SUBJECT: CLOUDY VCM CARS

TITLE: FLOW DIAGRAM

PORTABLE
CLONDY VCM FILTER

VCM FILTER

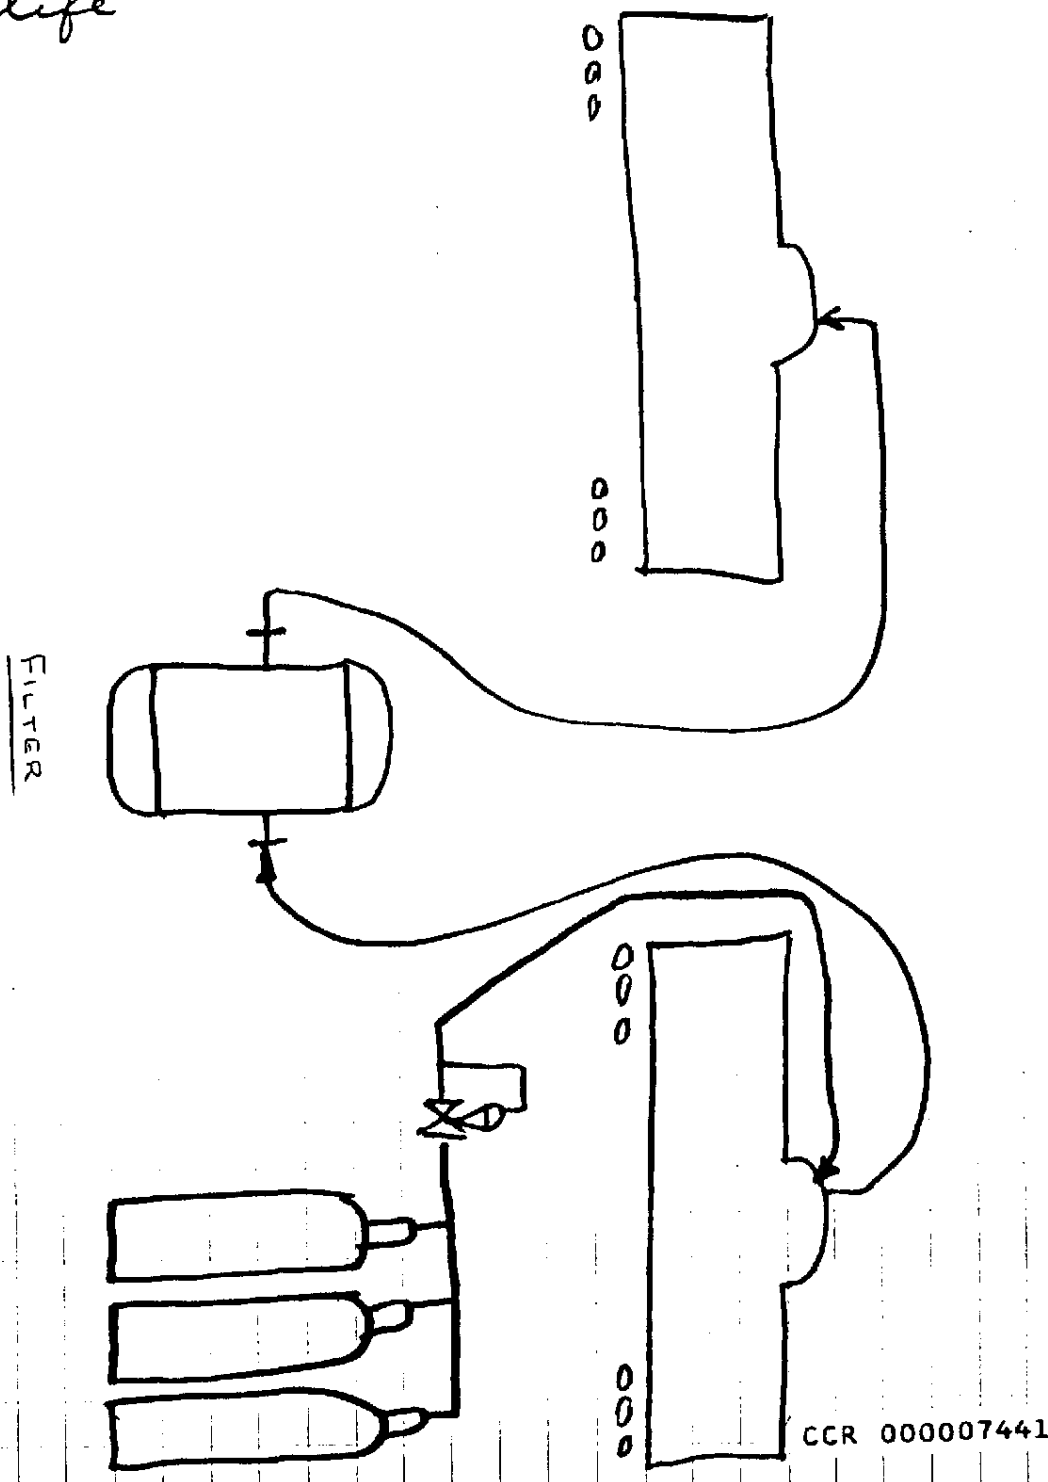
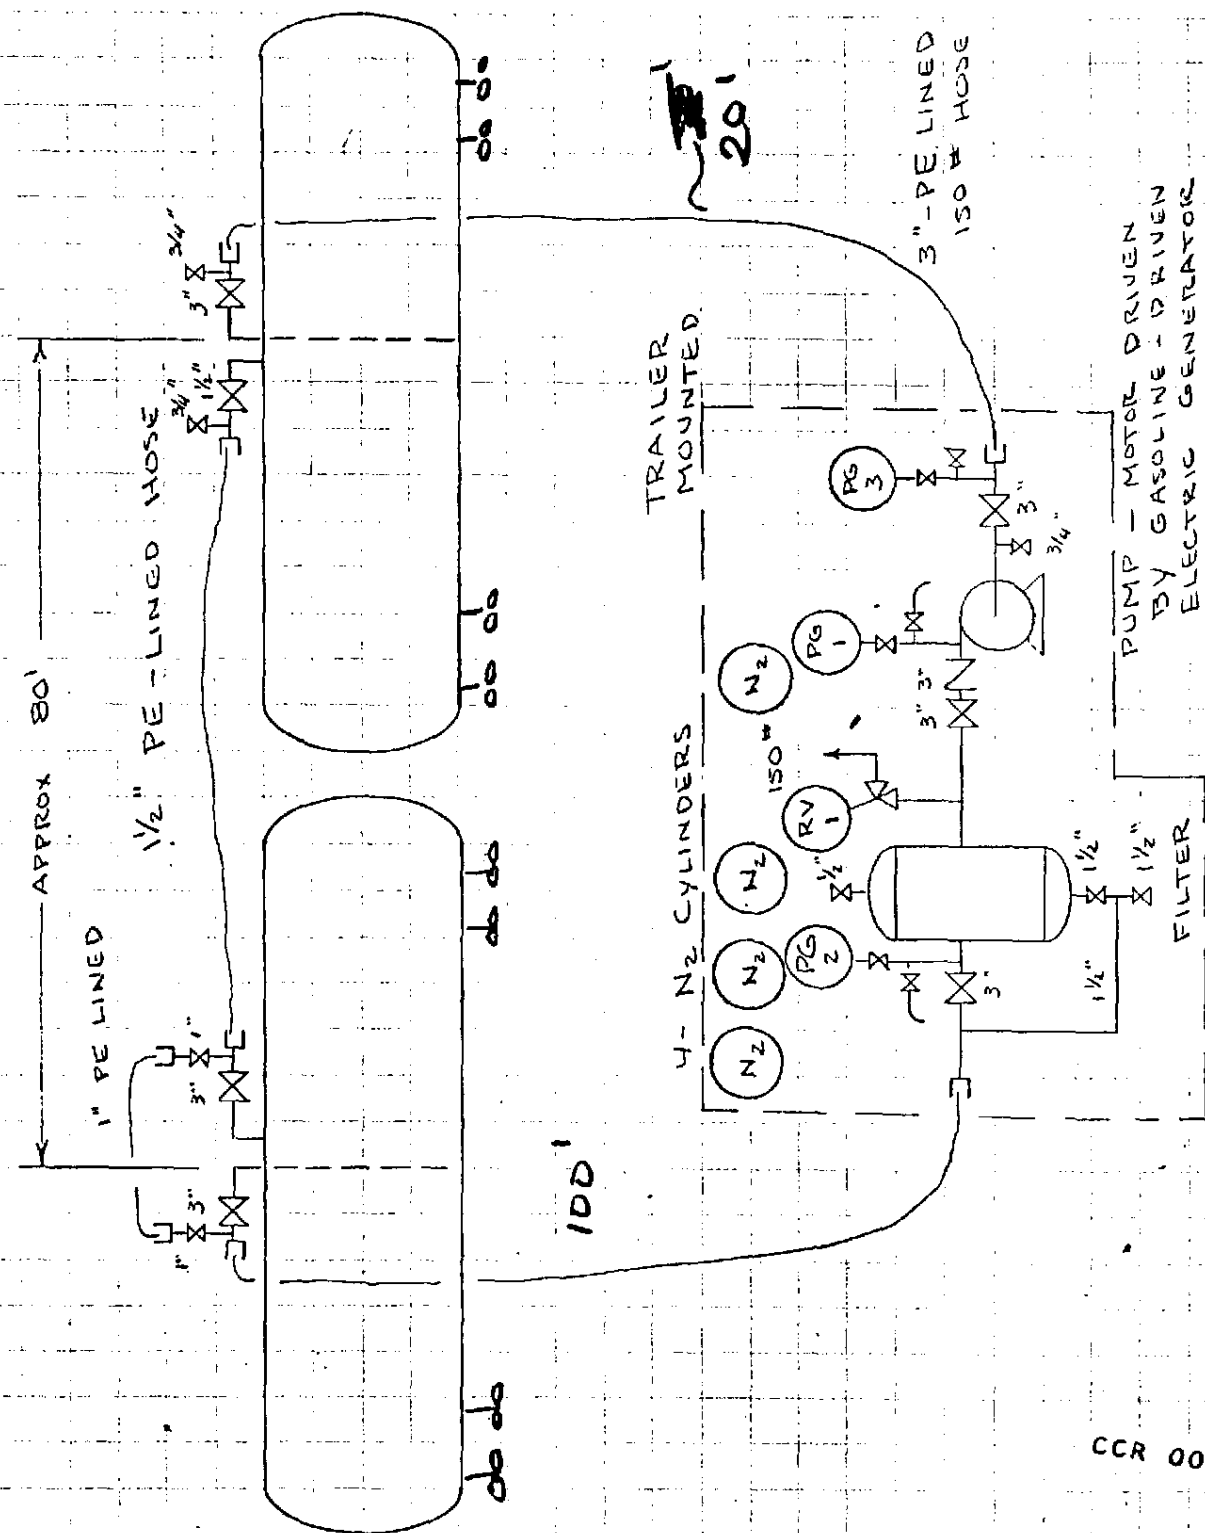
How much does it cost to get the
car to the siding?

Where is siding?

Bulls eye?

Want trailer there?

Ground both cars, and trailer
unit and generator?

O₂ analyzer for empty car?

Who will operate system?

Fire extinguisher
